**EARTHEN PIT REPORT/PERMIT**

**Conditions of Approval – January 4, 2012**

**Grand Valley Pit # 2; Facility ID: 426955**

POND #2 (AS-BUILT DRAWING)

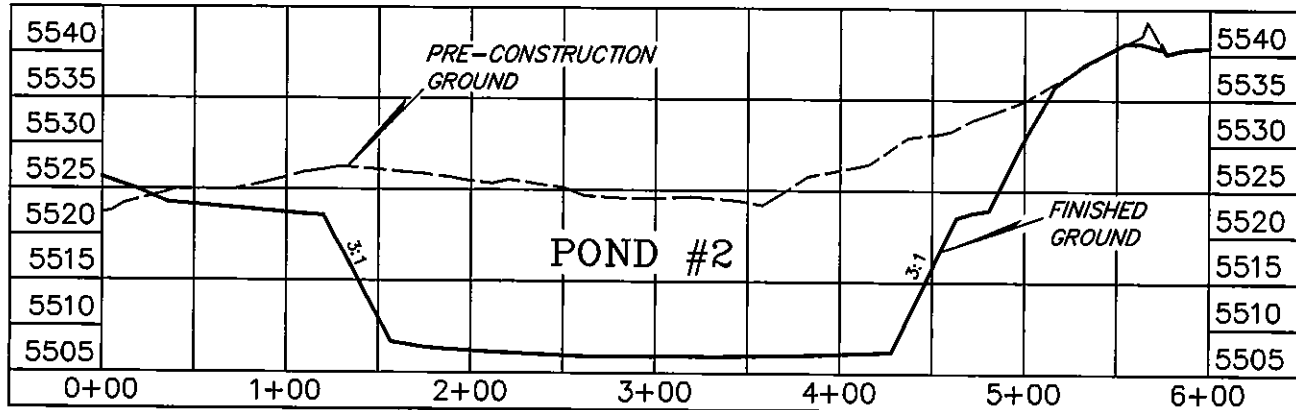
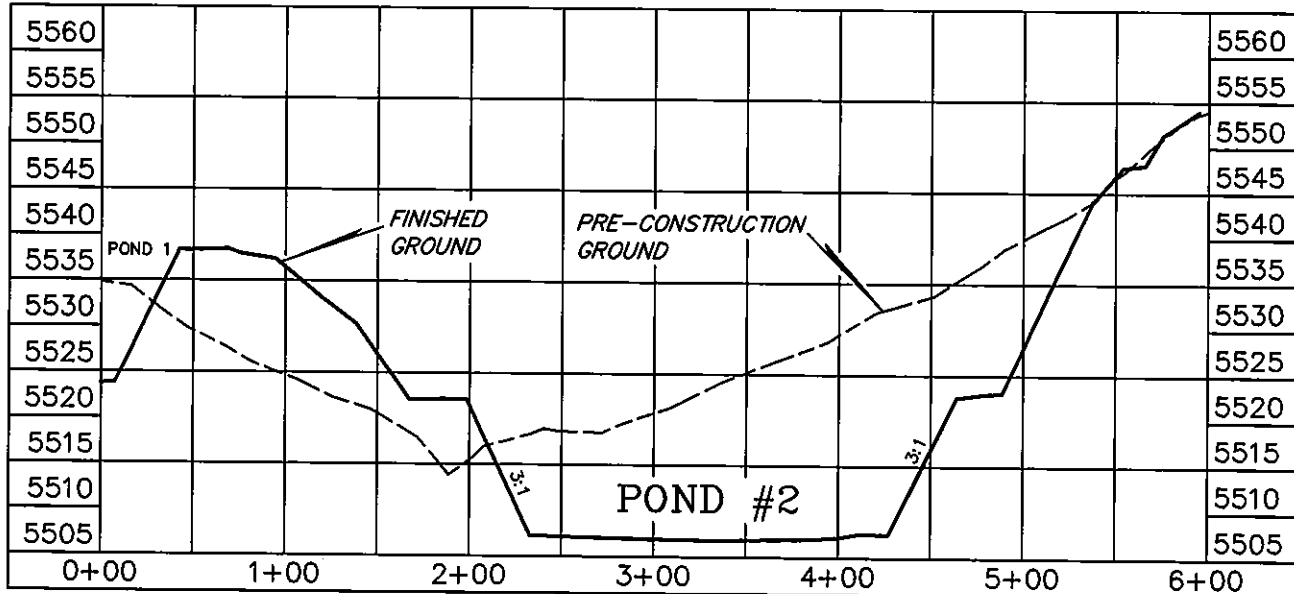
Pit is constructed in fill. Provide a Professional Engineer (P.E.) stamped review of the as-built construction of the pit and integrity of the pit.

Provide the as-built construction details.

The date provided on the "Sub Grade Acceptance" is the same for the Grand Valley Pit 1, Grand Valley Pit 2, and Grand Valley Pit 3. It appears that the "Sub Grade Acceptance" is applicable for Grand Valley 3. There were apparent weather related issues during the install of the 60 mil liner and 8 ounce textile under liner. Provide an engineering evaluation (by a P.E.) of the liner installation and "Sub Grade Acceptance."
